PLANS AND DOCUMENTS referred to in the PDA DEVELOPMENT APPROVAL
Approval no: DEV2016/759
Date: 25 January 2017
Queensland Government

AMENDED IN RED
By: Chessa Lao
Date: 10 February 2025
Queensland Government

AMENDED IN RED
By: Essen Joseph
Date: 15-Feb-2022
Queensland Government

nra-co-lab™
© Copyright Noel Robinson Architects Pty Ltd.
KINGSFORD
527 GREGORY TCE
STAGING PLAN
89084C16
SK9100
DATE: 16/01/2017 5:18:11 PM
SCALE: 1 : 200 @A1
SCALE : 1 : 200@ A1

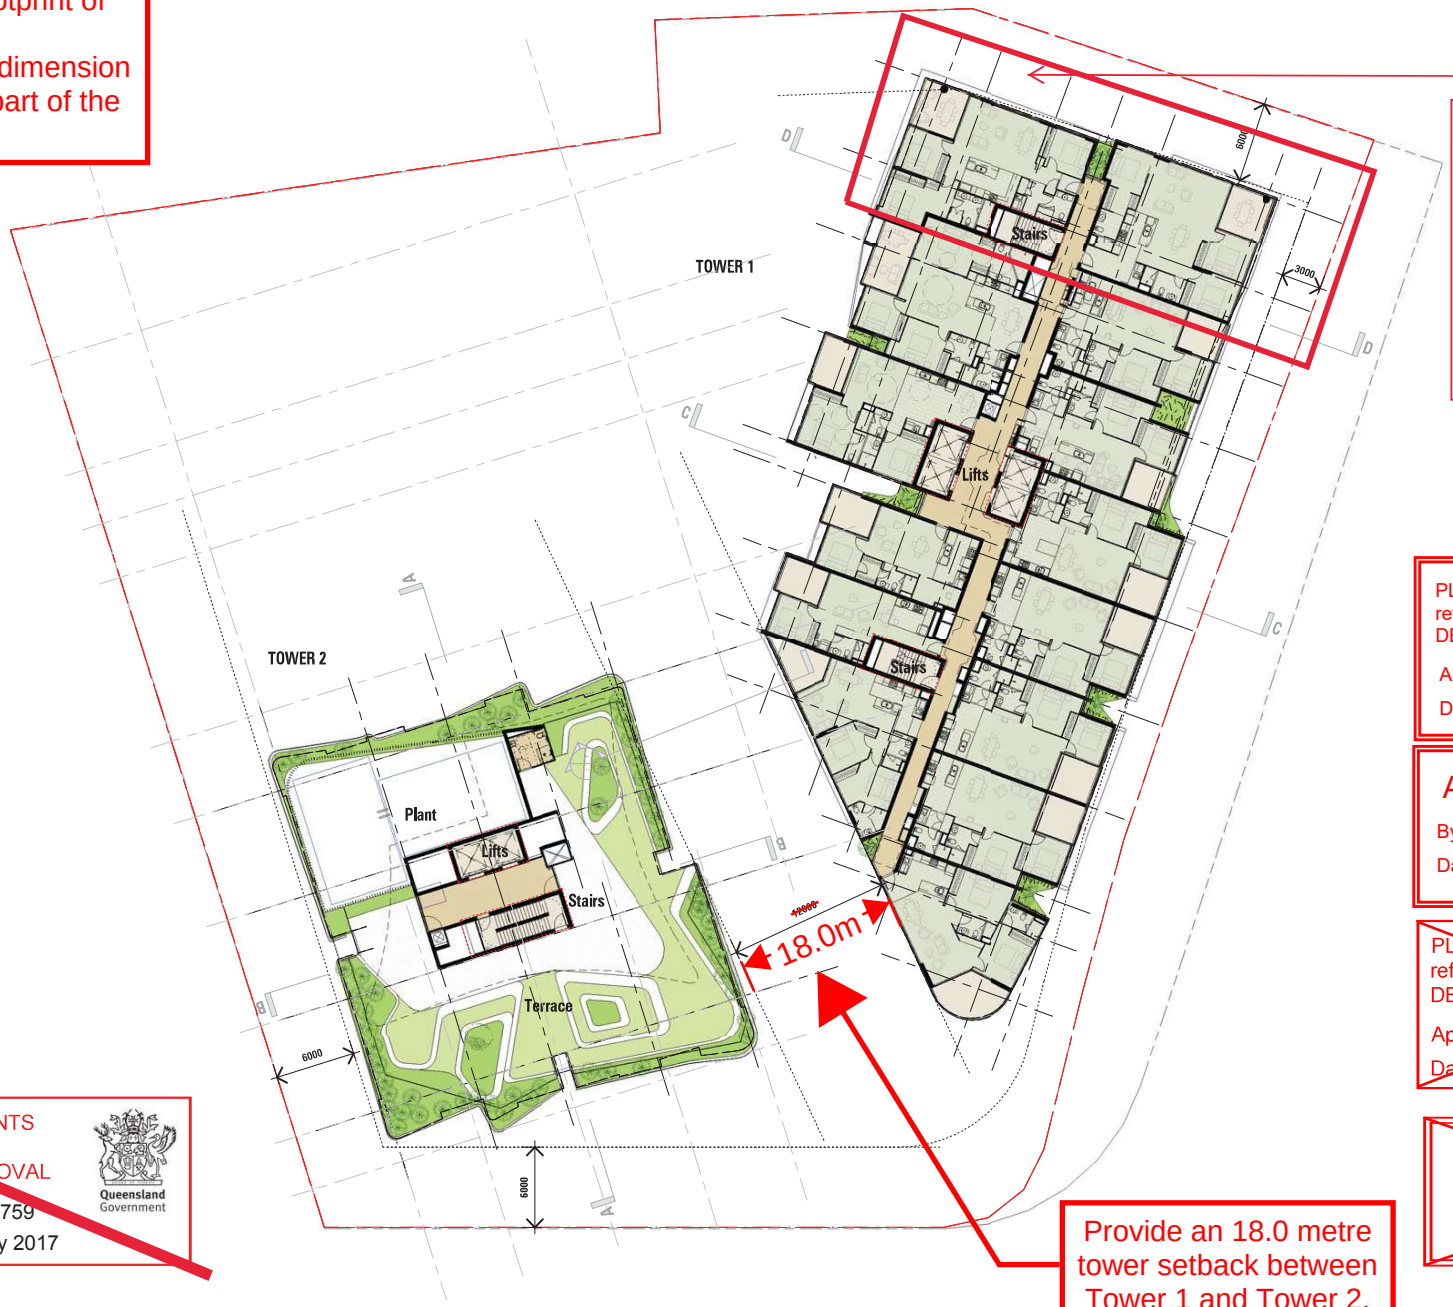
Each tower to achieve:
- a maximum tower footprint of 1,200m^2, and
- a maximum horizontal dimension of 50.0 metres for any part of the building.

Provide an 18.0 metre tower setback between Tower 1 and Tower 2.

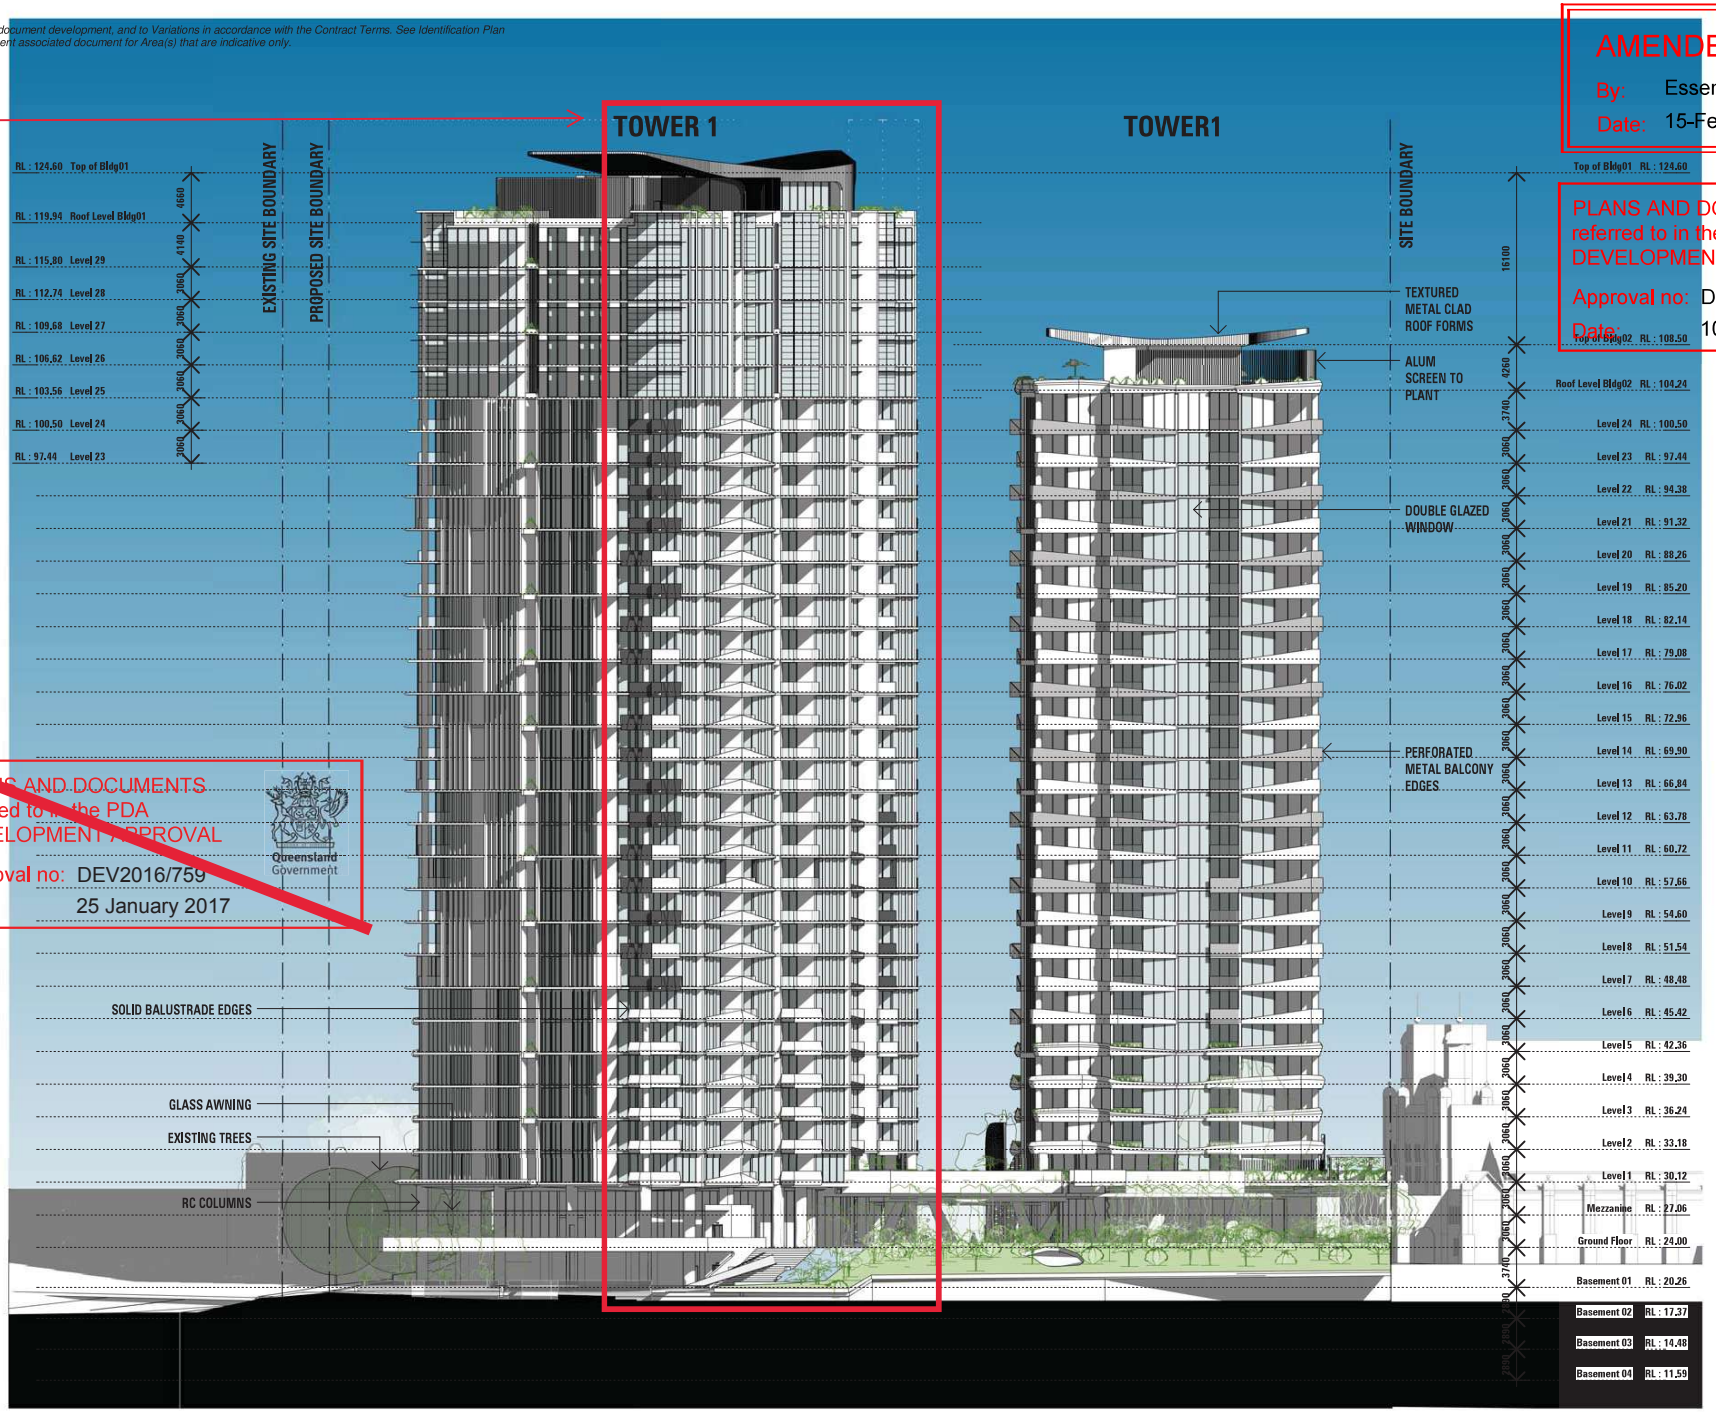
Increase building setback to 9m from boundary. Reconfigure apartments / building design to achieve setback.

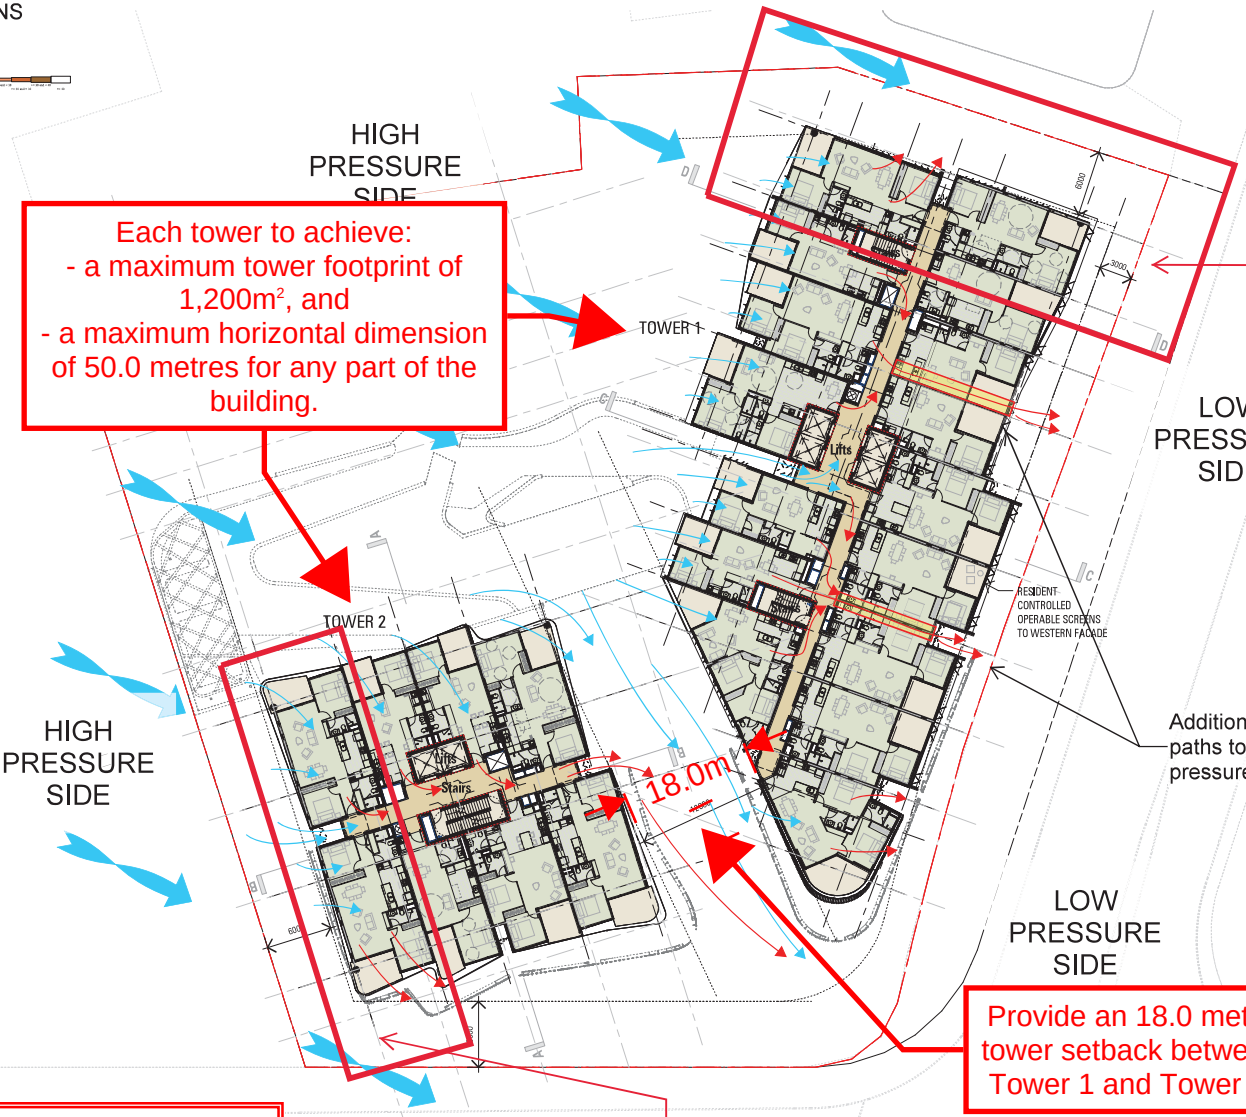
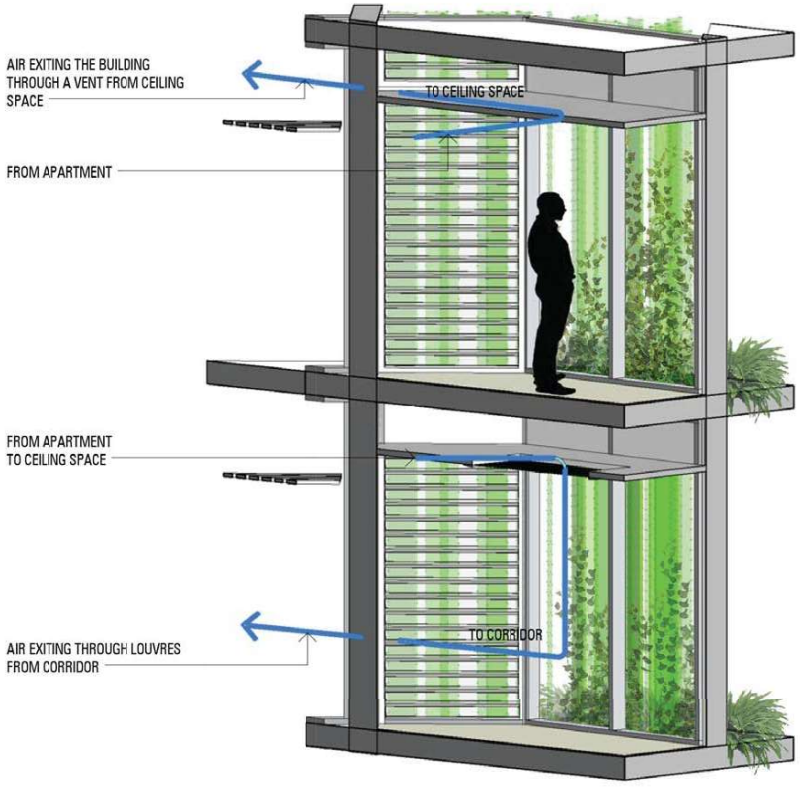
Each tower to achieve:
- a maximum tower footprint of 1,200m², and
- a maximum horizontal dimension of 50.0 metres for any part of the building.

Provide an 18.0 metre tower setback between Tower 1 and Tower 2.

Reconfigure outlook of habitable spaces of all apartments on the eastern boundary towards Gregory Tce and the Drill Hall (e.g. through the use of a fin-shaped floor plate, providing solid walls to the north-east, with large windows looking north and south).

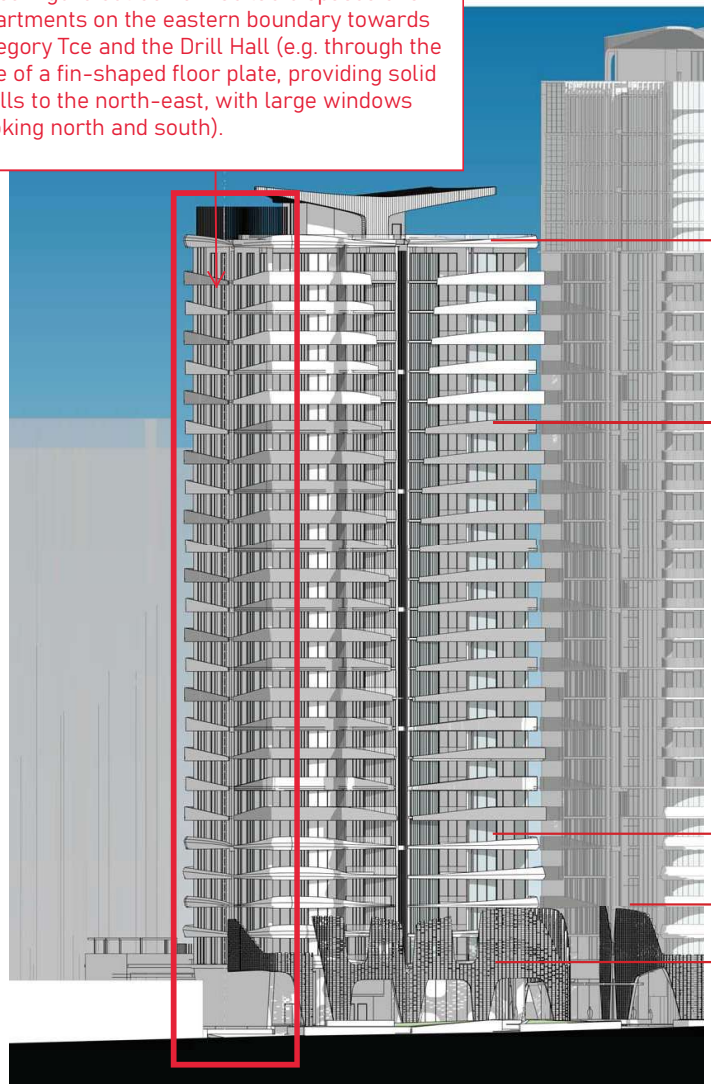
Reconfigure outlook of habitable spaces of all apartments on the eastern boundary towards Gregory Tce and the Drill Hall (e.g. through the use of a fin-shaped floor plate, providing solid walls to the north-east, with large windows looking north and south).

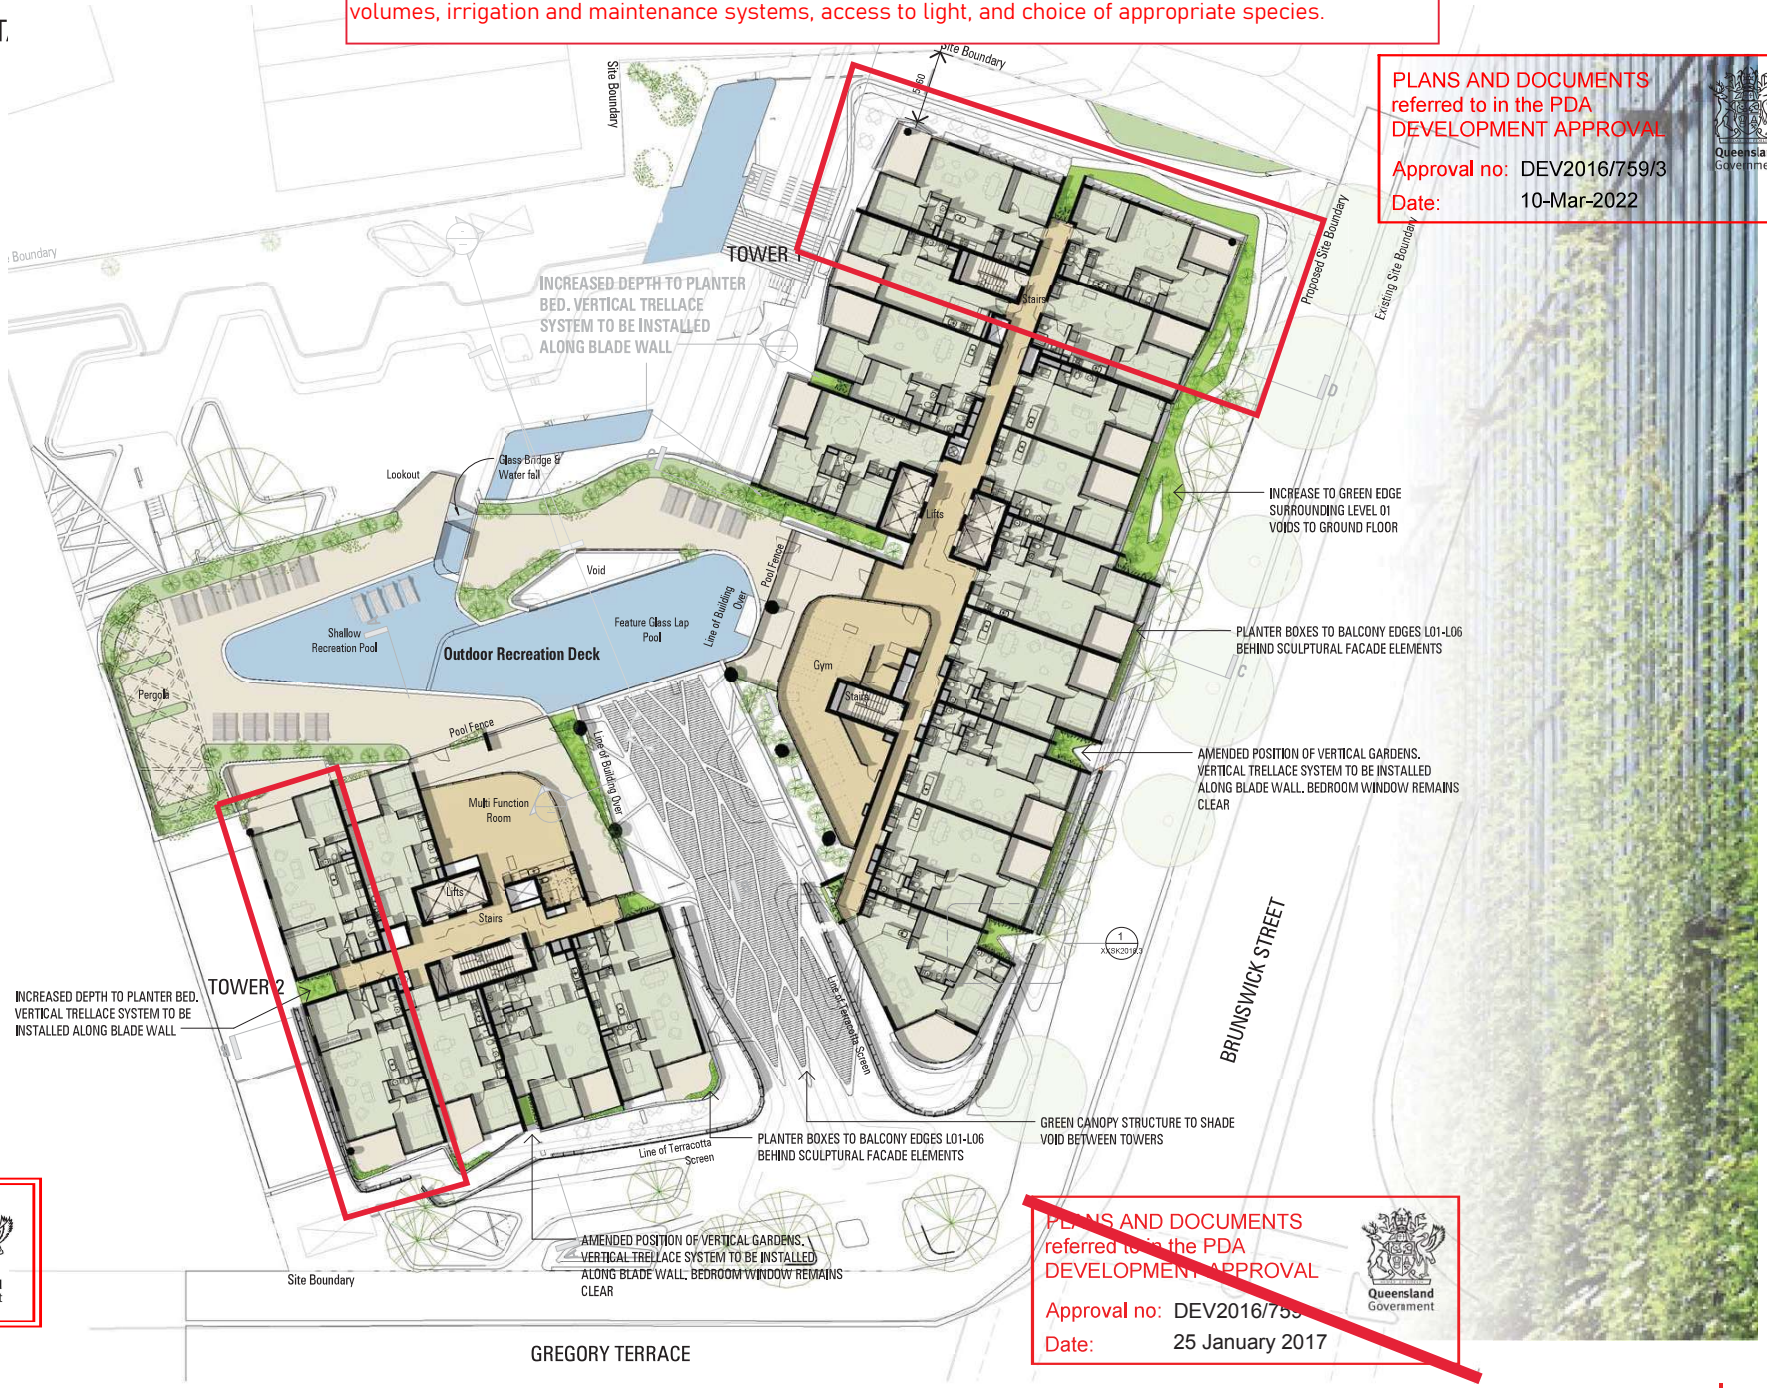
Detailed landscape architecture plans to be submitted, supported by details demonstrating the ability to establish and maintain the proposed vertical gardens, having regard for planter depths, soil/media volumes, irrigation and maintenance systems, access to light, and choice of appropriate species.

IN RESPONSE TO THE COMMENTS REGARDING THE EXTENT OF GREENERY THROUGHOUT THE SCHEME THE FOLLOWING AMENDMENTS HAVE BEEN MADE:

1. A VERTICAL TRELLIS SYSTEM IS PROPOSED TO BE FIXED ALONG THE BLADE WALL OF EACH RECESS. THEREFORE LEAVING A CLEAR OPENING TO THE BEDROOM WINDOW. THE PLANTING WIDTH HAS INCREASED AND WILL NOW BE MORE VISIBLE ALONG THE ELEVATION.

2. AN IRRIGATION SYSTEM IS PROPOSED TO MAINTAIN THE INTEGRITY OF THE PLANTING ACROSS THE SCHEME. DETAILS TBA

3. LEVEL 01 INCLUDES AN INCREASED GREEN EDGE TO EXTEND OVER THE RETAIL WALKWAY BELOW. THIS DENSELY VEGETATED GREEN EDGE WILL PROVIDE GREATER PROTECTION AND ADDRESS THE REQUIREMENT FOR AN EXTENSIVELY "GREEN" BUILDING

4. THE SIZE OF ALL PLANTERS HAS BEEN INCREASED TO PROVIDE MAXIMUM VEGETATION WHERE POSSIBLE.

5. PLANTER BOXES ARE PROPOSED ALONG BALCONY EDGES FROM L01- L06 TO ENHANCE THE GREEN AESTHETIC AND FACADE PERFORMANCE. THESE ARE TO BE MAINTAINED BY RESIDENTS AND ARE INCLUDED IN THE APARTMENT DESIGN ON THE LOWER LEVELS.

6. THE FEATURE SCREEN WILL INCLUDE CLIMBING VEGETATION AT GROUND TO PROVIDE A SOFT EDGE TO THE DEVELOPMENT. THIS UNIQUE SUBTROPICAL STRUCTURE WILL BE THE KEY LANDMARK OF THE DEVELOPMENT CREATING A DISTINCT GATEWAY TO THE SITE.
